City of **HOBART**

## APPLICATION UNDER HOBART INTERIM PLANNING SCHEME 2015

| Application No:       | PLN-16-00357-01  |
| Proposal:             | Partial Demolition, Alterations, Extension and Change of Operating Hours for Service Industry and Partial Change of Use to Business and Professional Services, and General Retail and Hire |

Figure 8. Proposed Site Plan

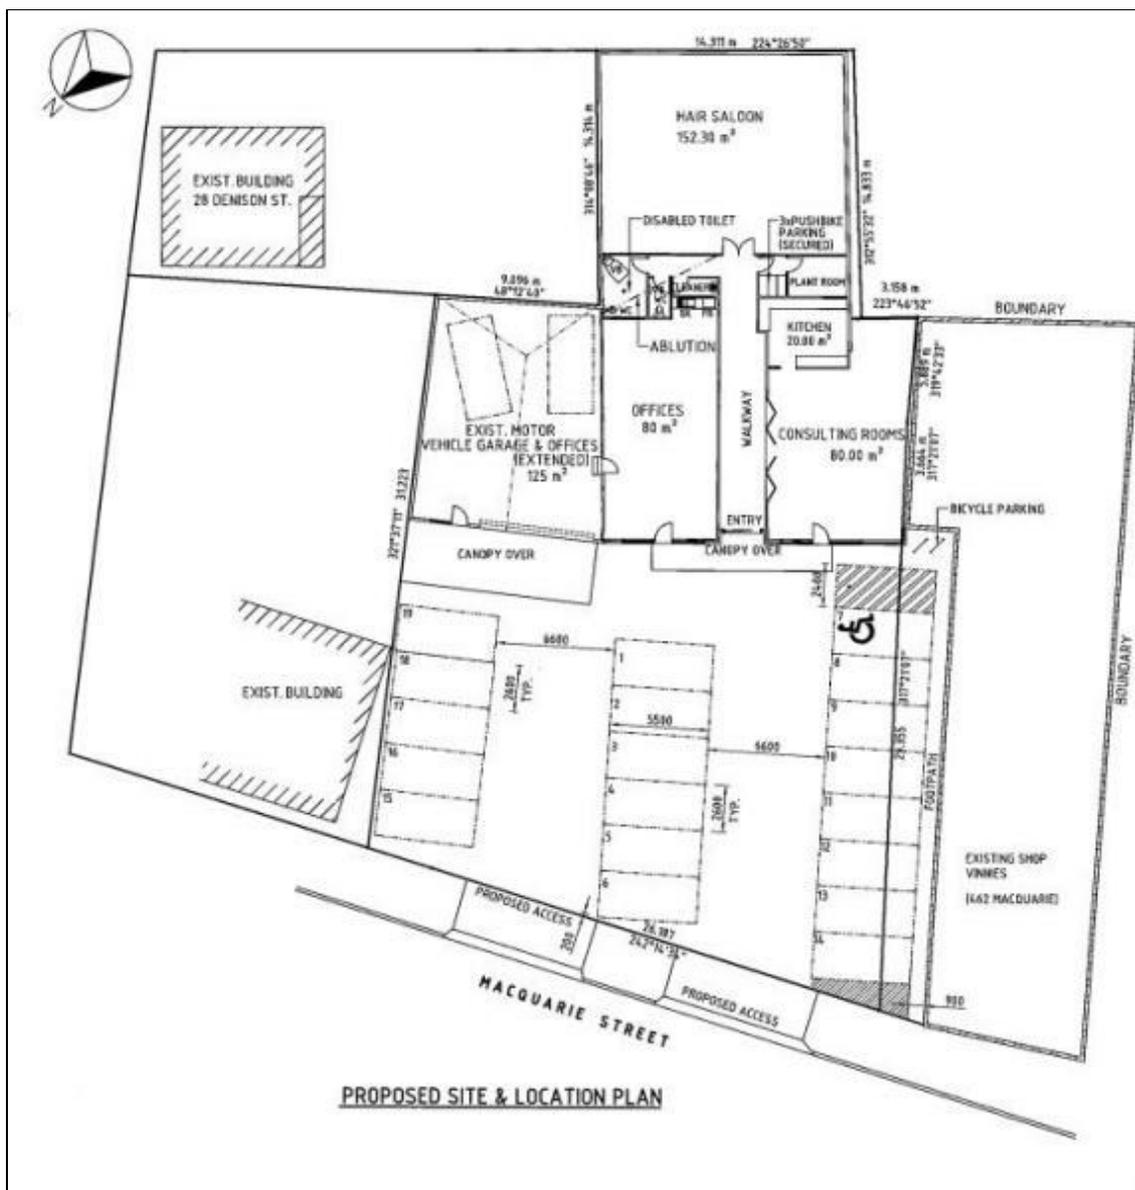
- 6.10.5 The proposed 19 car parking spaces are to be reduced to 18 via a recommended condition in the interest of the providing landscaping and allowing for adequate vehicle manoeuvring. However even at 18 car

6.11.1 The Council's Development Engineer is satisfied with the performance of the proposal in respect of the Parking and Access Code subject minor modification. The officer recommends the narrowing of the proposed accesses and for them to be one way only, as well as being clear of the existing bus stop. It is also recommended that car parking space 6 be removed to allow for adequate onsite manoeuvring. General conditions to ensure compliance with the relevant Australian Standards are also recommended.

6.12.1 The front area of the site is the existing concrete parking and turning area of the service station;; however once demolished, the area will form the car parking and circulation area for the proposed development and no landscaping is specifically proposed.

6.12.5 The most effective area to be utilised as landscaping is the frontage of the proposed parking and circulation area. This is supported by the Council's Cultural Heritage Officer. Landscaping will relieve the visual impact of the expanse of parking on the streetscape whilst still allowing for parking and adequate circulation to be accommodated. The expanse of hard surfaces is very much an existing situation; however the revision of the car parking to cater for the new uses allows an opportunity to include landscaping. With the removal of one car parking space from the central bank of spaces, there is room to provide landscaping along the frontage, in front each of the three rows of car parking. A condition is therefore recommended for landscaping in these areas.

**Landscaping to the satisfaction of the Council's Director City Planning must be installed along the front of the three parking areas prior to the first occupation. The vegetation must be maintained, and replacement vegetation must be planted if any is lost.**

**The car parking space No 6 shown on the drawing No 3743 A3 Revision 2 submitted on 25 October 2016 does not comply with the Australian Standard AS/NZS 2890.1:2004, and as such is not approved.**

1. **Show the layout of the car parking for the eighteen (18) parking spaces in accordance with the Australian Standards AS/NZS 2890.1:2004 and AS/NZS 2890.6:2009, to satisfy the above requirement.**
2. **Show wheel stops for car parking spaces 7-14 to prevent conflict with pedestrians on the footpath.**
3. **Show bollards (or approved equivalent that maintains vehicular and pedestrian sight lines in accordance with AS/NZS 2890.1:2004) along the front boundary where vehicular access points are not present, to prevent unauthorised vehicular access to the Council footpath.**
4. **Show two (2) 3.6m wide vehicular crossovers and vehicular access points in accordance with TSD-R09-v1 with a minimum kerb length between crossovers of 1.0m**
5. **Show new vehicular crossovers clear of existing bus stop.**
6. **Show separate entry and exit vehicular access points, and a one way aisle system.**

*Figure 12: Showing the extent of the building envelope discretion for the extended motor vehicle garage, adjacent to 450-454 Macquarie Street.*

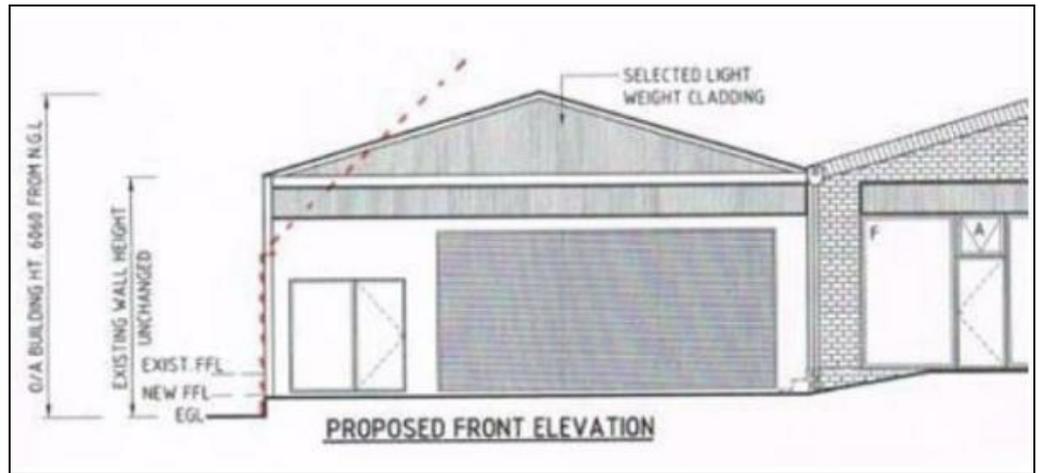
- 6.8.1 The proposed alterations to the motor vehicle repair workshop include the replacement of the existing walls however the wall is to also be extended towards the front boundary by an additional 4m, with the building to have a shallow pitch gable roof. There is also a canopy proposed that extends

In respect of the adjoining properties at 450-454 Macquarie Street, the northern aspect of their rear yards means that there is only additional impact to the rear of the property in the late afternoon, however with only a very limited additional impact throughout the winter months of the year.

The visual impact of the extension of the wall on the boundary as viewed from the properties at 450-454 Macquarie Street presents an additional impact particularly when combined with the proposed canopy. It is appreciated that there is a great benefit in the operational functionality of the workshop in having the ability to fit two vehicles length ways. The proposed length allows the minimum space practicable for this to happen. The retention of the existing wall height maintains the scale of the existing structure with the gable roof sloping away from the property reducing the visual impact in proximity to the boundary. The service station building and adjoining workshop structure are also to be removed which although not sited on the boundary, currently presents a continuous view of buildings that extend the length of the site.

The proposed canopy extends another 3.6m beyond the extended workshop and is considered an extension of the building that unnecessarily contributes to the visual impact of the building and closes visible open spaces when viewed from the rear of the properties at 450-454 Macquarie Street. It is appreciated that a canopy provides some protection from the elements such as sun and rain; however a much reduced canopy could still provide adequate protection with a reduced visual impact when viewed from the rear of the adjoining properties at 450-454 Macquarie Street. It is therefore suggested that a condition be included on the permit that requires that the canopy be reduced to 1.5m which is consistent with the other proposed canopy and provides a reasonable level of protection from the elements of the internal spaces of the workshop.

- Removal of bus stop as recommended in the Traffic Impact Assessment.
- 7.3 In respect of the proposed impact from the proposed extension of the workshop and building there appears to be some confusion to the extent of the development. The existing central building is to be retained with no change to the existing boundary walls to the side and rear. The motor vehicle repair workshop is to have the existing block work walls replaced at the same height however it is to be extended towards the front, in line with the central building and includes a gable roof with canopy. The potential impacts relative to the building envelope encroachments were assessed against the performance criteria and considered acceptable subject to a condition requiring a reduction in the length of the canopy to the motor vehicle repair workshop.

Figure 13: Showing the location of the building envelope discretion adjacent to 55 Darcy Street.

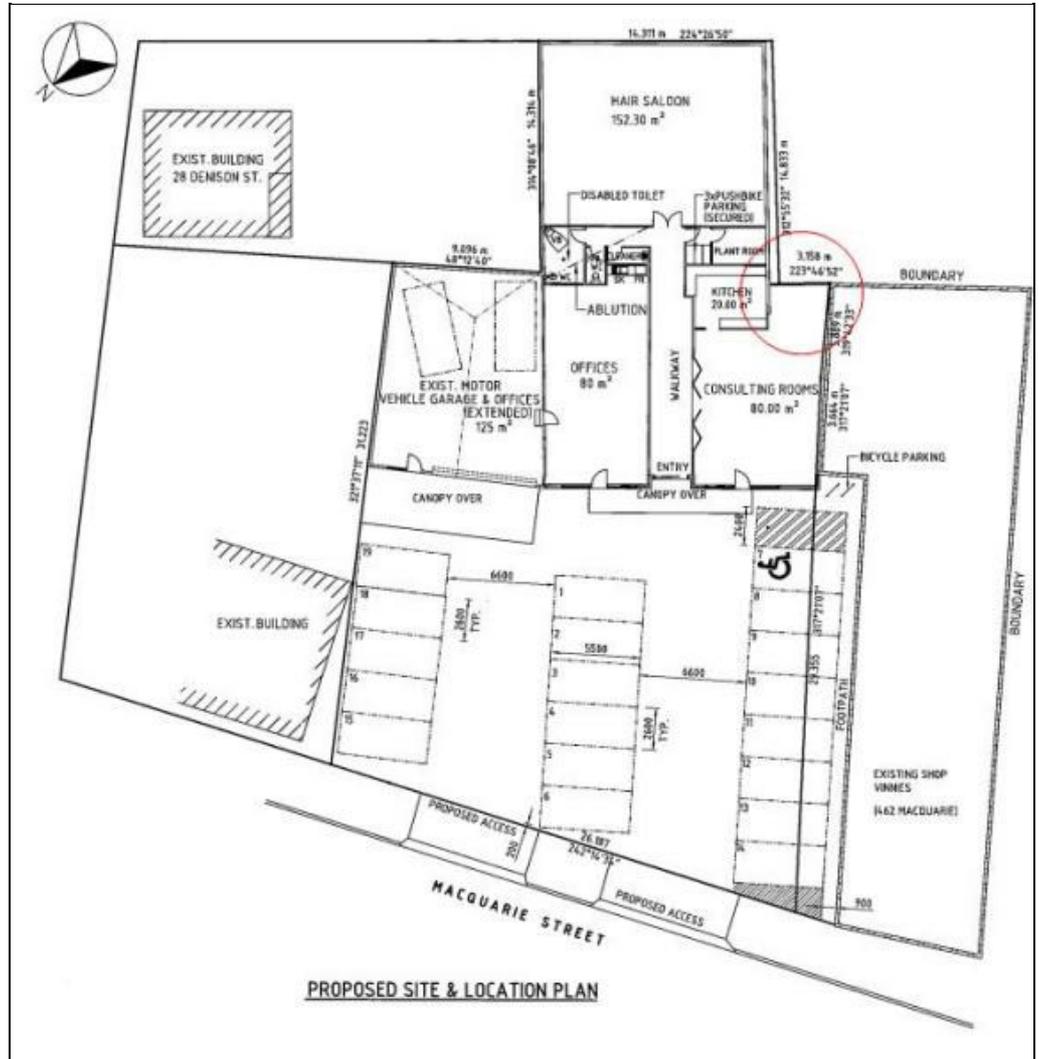
- 6.8.2 The other relevant area is the small section of infill development with a new section of wall adjoining the rear of 55 Darcy Street (circled in red below).

The other component of the building envelope discretion relates to the section of wall at the rear of the consulting room that infills the existing gap between the buildings. It adjoins the very back corner of 55 Darcy Street where there is a fenced section in between the existing buildings. The proposal adds a wall a metre higher than the existing fence enclosing the gap between the buildings. In terms of impact to 55 Darcy Street, it is not considered to be unreasonable due to the very limited additional overshadowing due to the existing buildings either side. Also due to the narrow section of infill, it is not considered to cause an unreasonable visual impact considering its location between the buildings and being at the very rear corner of the yard.

6.8.7 The proposal complies with the performance criterion.
